SERVICE LETTER

No. 883

Piper Aircraft Corporation

Wing Flap Rivet Installation

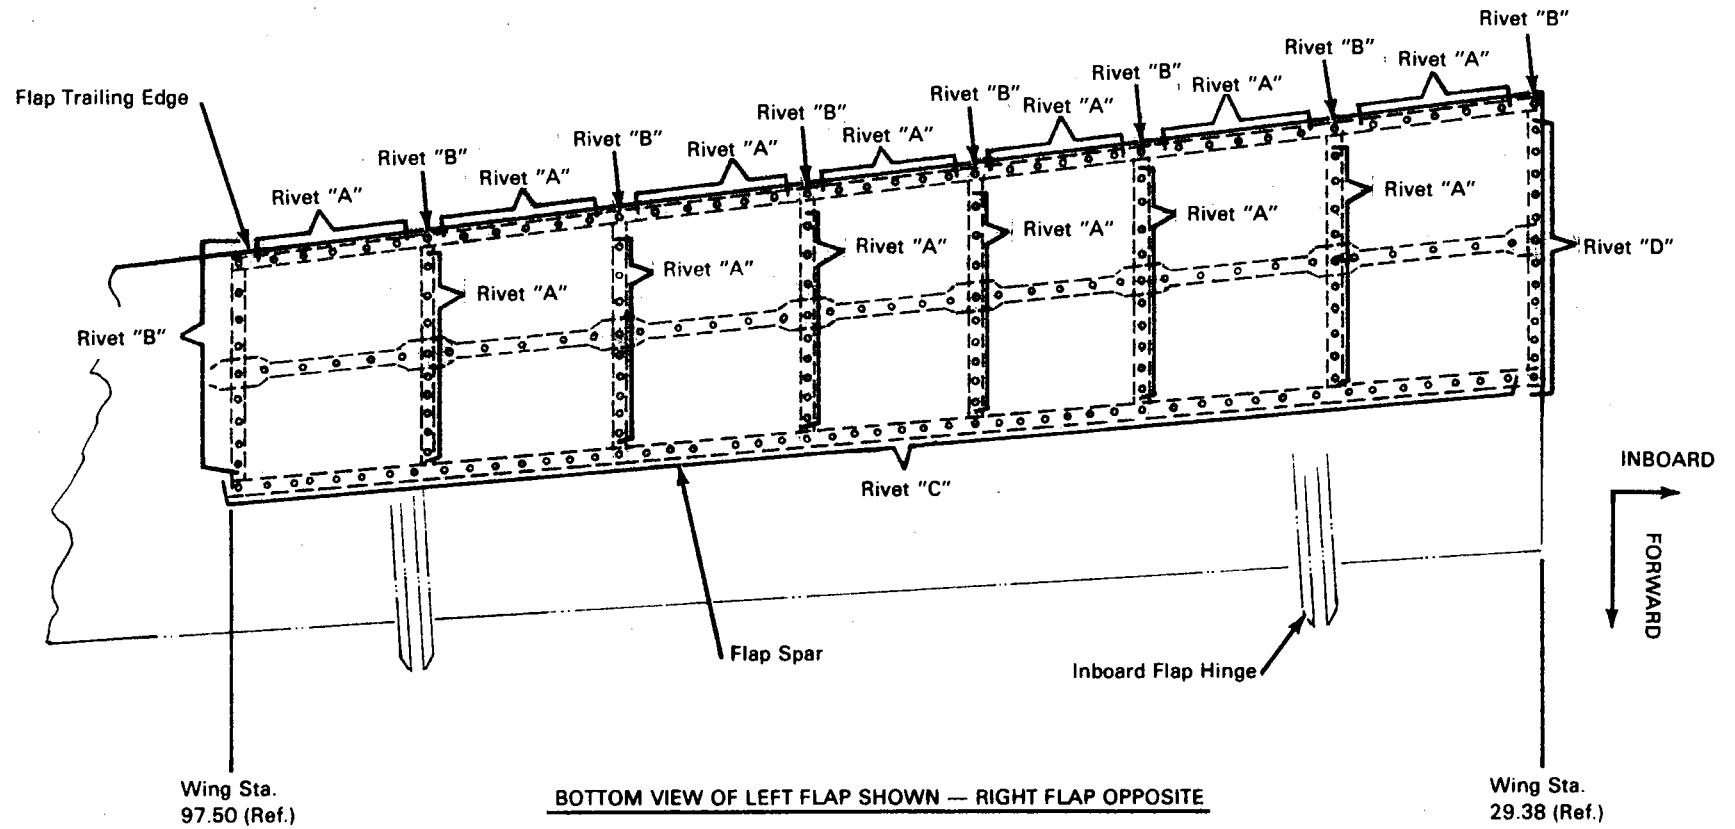
Reports have been received of loose rivets on the bottom surface of the wing flap assemblies. In several instances recurrent loosening of rivets has occurred in aircraft on which loose rivets were replaced.

1. Gain access to the bottom surfaces of the left and right wing flap assemblies.
2. Replace any rivets showing evidence of looseness. Refer to sketch for proper replacement part.
3. On the bottom surfaces of the wing flap assemblies, from and including Wing Station 29.38 to and including Wing Station 97.50 between the flap trailing edge and the flap spar including the flap spar, add appropriate rivets midspace between existing rivets where the distance between the existing rivets is one (1) inch or greater.
4. Make proper log book entry of compliance with this Service Release.

RIVET	PART NO.
A	NAS1738B-4-1 (P/N 522 881)
B	NAS1738B-4-2 (P/N 522 882)
C	NAS1738B-4-3 (P/N 522 883)
D	MS20470AD3-3 (P/N 420 200)
